DEVELOPMENT REVIEW

Property address or Location 951 112th ST FORT PIERCE FL 34450
 Parcel ID #(s) 2404-804-0020-000-0
 Project description PROPOSED DUPLEX

Subject: Response to Review Comments - Minor Site Plan Amendment P18-087-A1 Go Team Industrial Park Storage Yard

**RE : 1021 N. 12th Street Site Plan
PZSITE2025-00021**

SHEET TITLE UTILITY PLAN	
DATE 01/22/2025	SHEET
SCALE N/A	C-3A
DRAWN BY DC

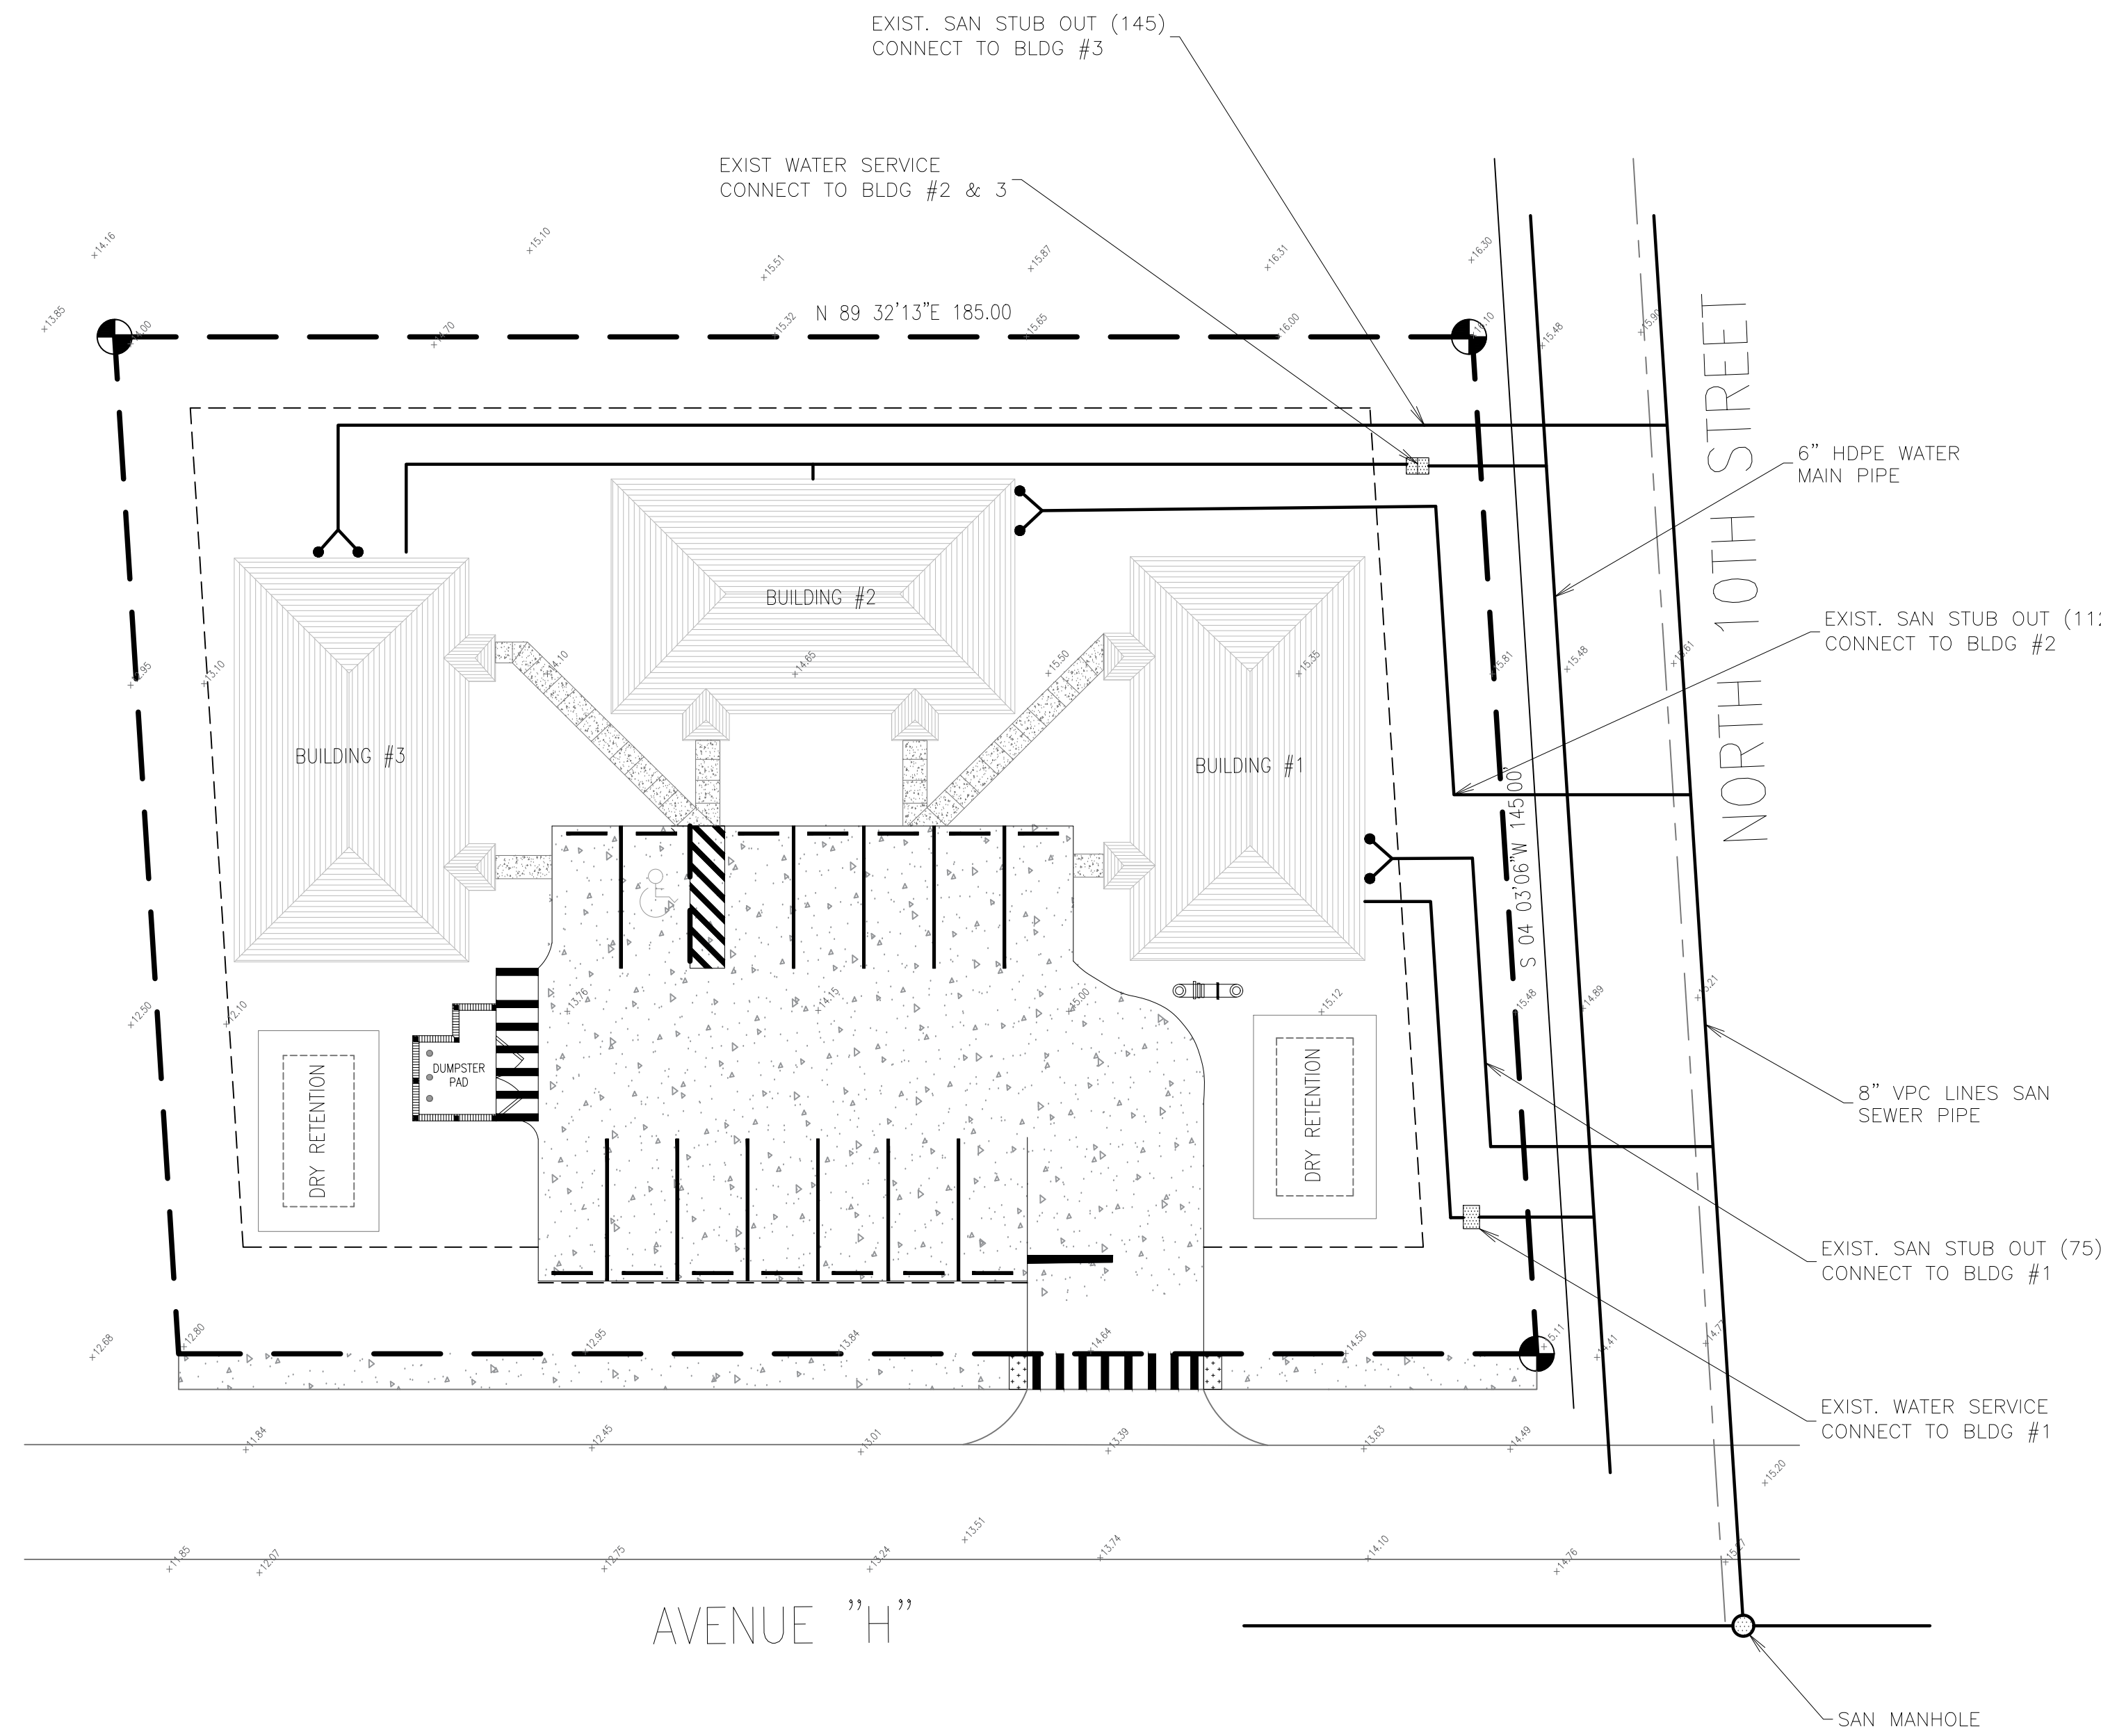
PARKING LOT AREA HAS BEEN REVISED. PLEASE REFER TO THE REVISED SITE PLAN SHEET C-2
